USC Reference: USC114

Council Reference: MCU25/0052

SARA Reference: 2509-48001 SRA

INFORMATION REQUEST AND FURTHER ADVICE RESPONSE 500-502 ROSS RIVER ROAD, CRANBROOK

Figure 9: TMR Acoustic Barriers

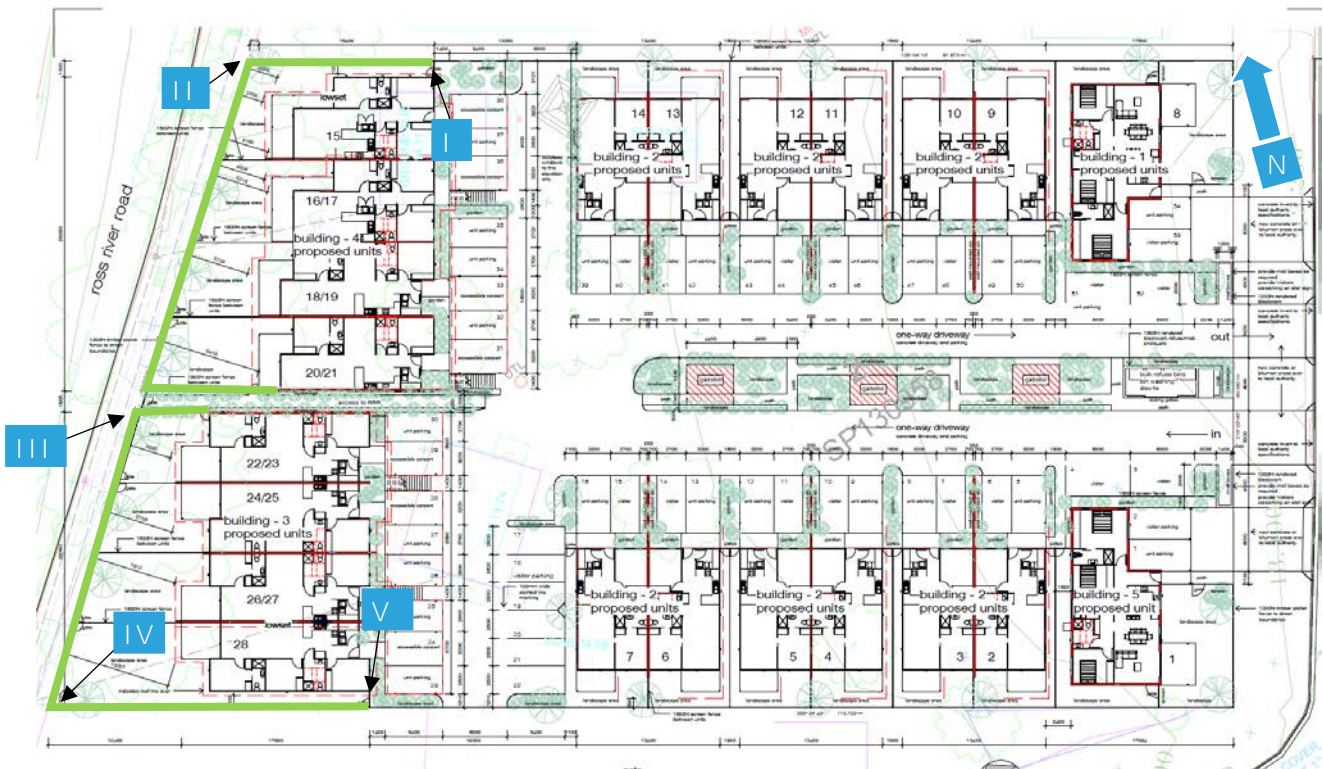
In response, the applicant has proposed a 1.8m high timber fence along the site frontage. However, this measure does not meet the noise requirements of State code 1.

To demonstrate compliance with PO39 - PO41 of State code 1, you must submit a noise assessment report prepared by a suitably qualified acoustic consultant and certified by a Registered Professional Engineer of Queensland (RPEQ). The report must detail appropriate noise attenuation measures that ensure compliance with the relevant noise criteria.

The report should include mitigation strategies for predicted traffic noise levels generated on the state-controlled road impacts over a 10-year horizon from the commencement of the development use. Guidance on preparing the assessment and determining road traffic noise impacts is available in the Transport Noise Management Code of Practice.

The report provides certified recommendations including a 2m high acoustic fence to achieve the internal and external acoustic criteria for accommodation uses. These measures collectively demonstrate that the development can meet the relevant noise thresholds and achieve a compliant acoustic environment for future residents.

Acoustic barriers are recommended to be constructed along the passive recreational boundaries of units 15 to 20 and 22 to 28 as shown in Figure 9 below. The barriers are recommended to be built to a height of 2.0 metres above the finished recreational level or boundary level (whichever is higher).

The barrier shall be constructed using materials that achieve a minimum surface density of 15kg/m². The barriers shall be constructed in accordance with Main Roads Standard Specification MRTS15 "Noise Fences". The barrier shall be free of gaps and holes.

Figure 5.5 – Post Development - Northern and Southern Stormwater Catchments

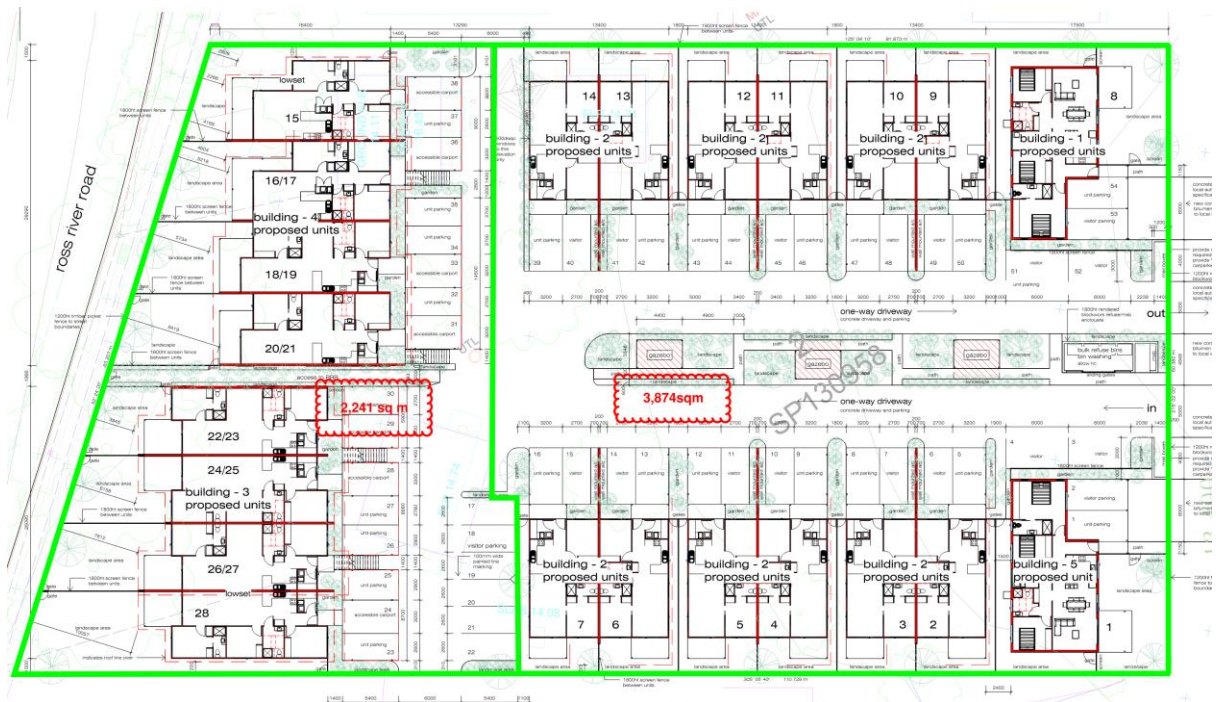
You have submitted a site-based stormwater management plan identifying northern and southern catchments. The southern catchment directs runoff to the local road network, while the post-development northern catchment (2,247 m²) discharges via pits and pipes into the existing stormwater system in Ross River Road during minor events. In major events, excess runoff will flow overland onto Ross River Road.

The report concludes that post-development runoff will decrease across all events from the minor (2-year ARI) to the major (100-year ARI). However, key assumptions in the calculations require further justification. The pre-development impervious area is assumed to be 0.65%, which appears to underestimate the actual impervious fraction. The post-development time of concentration is assumed to be 10 minutes, which is likely overestimated. A value of 5 minutes would be more appropriate for the northern catchment.

You are requested to provide a revised stormwater management plan that either justifies the current assumptions or updates them to reflect a more accurate impervious area and a 5-minute time of concentration for the assumptions. The revised stormwater management plan should also include rainfall intensities for the relevant design events, as referenced in the original report.

With reference to the Architectural drawings 'Area Schedule for Landscaping' the grassed areas and garden beds make up 32% of the land area, giving a fraction impervious for the subject site 68%, which is slightly less than assigned 70% for a Medium Density Residential zoned site in accordance with the Townsville City Council Planning Scheme.
